DEVELOPMENT SERVICES COUNCIL REPORT

From: Paul Gipps, CAO File No: DP 22-26

Subject: DP 22-26; Development Permit with Variances; 3401 Sundance Drive

Figure 11: Setback variance for Sundance Units (1-20) – example of Building 1, units 1-4.

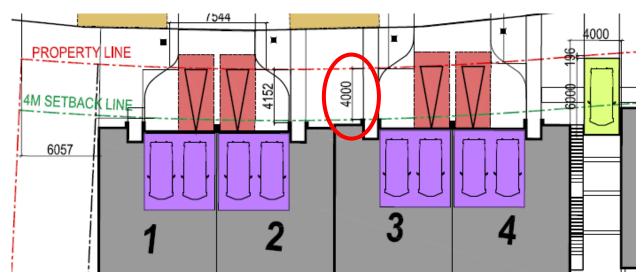
1. S.10.11.4(g)(i) – Reduce the minimum required front parcel boundary setback (Sundance Drive) from 6.0 m to 4.0 m (varies), in accordance with the site plan (Attachment 2, Figure 1 and 11). This variance affects all five buildings located on Sundance Drive. Recent amendments to the Bylaw allowing for setback measurements to be taken from the back of a curb or sidewalk were not added to the R4 Zone.

Since the Sundance Drive Right of Way will accommodate 3-4 metres of driveway from the curb to the property line, plus the additional 4 m setback (minimum) from

the property line to the buildings, vehicle overhang into the physical roadway is not anticipated. Staff support this variance.

Figure 12: Site plan, parking setback variances with insert.

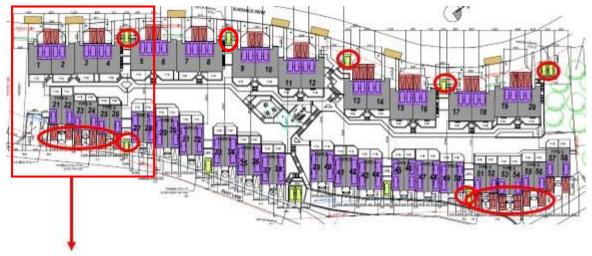
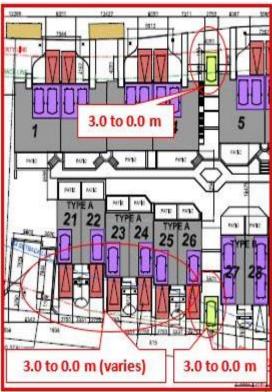
This proposed variance affects nine of 12 visitor spaces, one (and sole) loading space, and 13 required townhouse parking spaces proposed in front of the garages for the Type A and C units located on the laneways (i.e., units 21-26, 51-56, and 58).

Staff have concerns about the potential impact of these variances, specifically in regard to the laneway and site circulation.

The intent of this bylaw regulation is to provide a buffer between more intensive multiple-family surface parking areas and public or private roadways, typically via landscaping. In this circumstance, the regulation is applied due to required parking being proposed in tandem with, and in front, of the single garages adjacent to the laneway. While this particular application of the parking regulation was not specifically considered with its original intent, it does reflect overall site design

Figure 15: Over-height retaining walls (2)

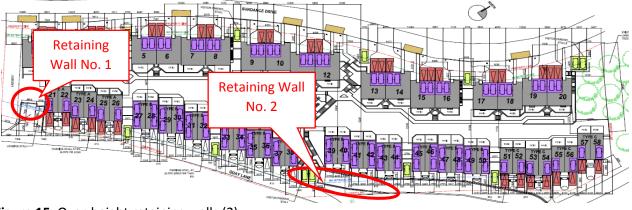
The proposal includes two over-height retaining walls up to a maximum 3.5 m. The first retaining wall (Figure 15) is proposed to accommodate the emergency turnaround at the terminus of Ensign Quay Lane. Staff are supportive of this variance, given the challenging topography of the site, the critical purpose of the turnaround, and the limited impacts to adjacent properties.

Figure 16: Over-height retaining wall No. 2.

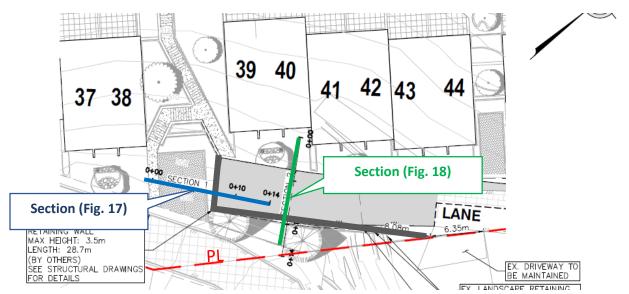
The second over-height retaining wall (Figure 15-18) is proposed to extend the existing physical laneway on Ensign Lane to accommodate vehicle access/egress to units 39-44, as the existing site topography is steep at this location. The wall is

Staff have do not have concerns with the height of the wall, but do have concerns due to its location and the proximity of the extended portion of laneway to the units near its terminus as it relates to on-site circulation and safety. Proposed units 39 and 40 are likely to encounter challenges with egress from their tandem garages given the minimal space available for turning. Where turning is possible, the wall results in an immediate 3.5 m drop in elevation to surrounding steep slopes and vistor parking spaces. Winter conditions and snow storage at the terminus of the lane is also likely to further exacerbate this hazard.

Staff are recommending that Council direct the applicant to revise the design of the extended portion of Ensign Lane to include increased safety elements consistent with best practices and the City's Hillside DPA guidelines and demonstrate that turning movements can be reasonably accommodated to any units near its terminus.

Figure 19: variance to the width of driveway crossings (4 of 8 crossing over 7.0 m shown here).

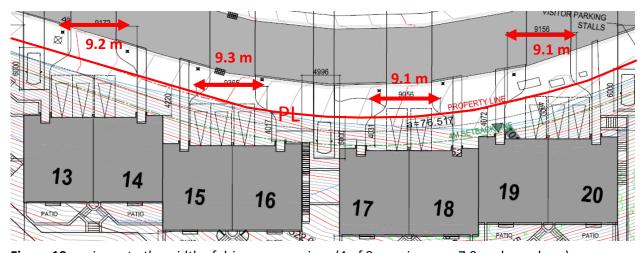
A variance to the maximum width of driveway crossings is to accommodate double driveways for the units on Sundance Drive. This variance applies to eight of 10 paired driveway crossings. Staff do not anticipate impacts from the paired driveways and support the variance.

Figure 20: Variance to forgo turnaround on Ensign Lane

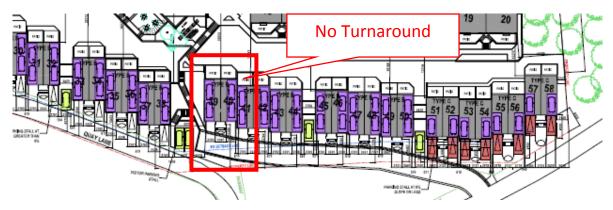
The City's Works and Services Bylaw requires private hillside lanes to include a turnaround at or near their terminus. This is for the purpose of improving vehicular

circulation, particularly with emergency or service vehicles (snow clearing, delivery, waste management). In the absence of a turnaround, it is anticipated that larger vehicles would need to turnaround on private driveways or reverse in or out of the laneway. This variance applies to Ensign Lane only, as a turnaround is proposed on Ensign Quay Lane.

Although the City's Fire Department has confirmed they do not oppose the variance, the City's Engineering Department has stated that the turnaround is important for vehicle circulation and safety. In the absence of a turnaround, service and emergency vehicles would potentially be obstructed or obstruct the laneway. Passenger vehicles are also anticipated to have challenges turning around, given that the laneway contains only two visitor spaces and short driveway apron depths for units 39-50. Also, units 51-58 include only single garages; while consistent with the Zoning Bylaw regulations for off-street parking, including required parking in front of the garages adjacent to the laneway may exacerbate anticipated access and circulation challenges.

- Reallocate the number of visitor spaces for each laneway to be proportional to the number of units;
- Revise the design of the extended portion of Ensign Lane to include increased safety elements consistent with best practices and the City's Hillside DPA guidelines and demonstrate that turning movements can be reasonably accommodated to any units near its terminus; and
- Clearly provide a location for snow deposition on Ensign Lane.
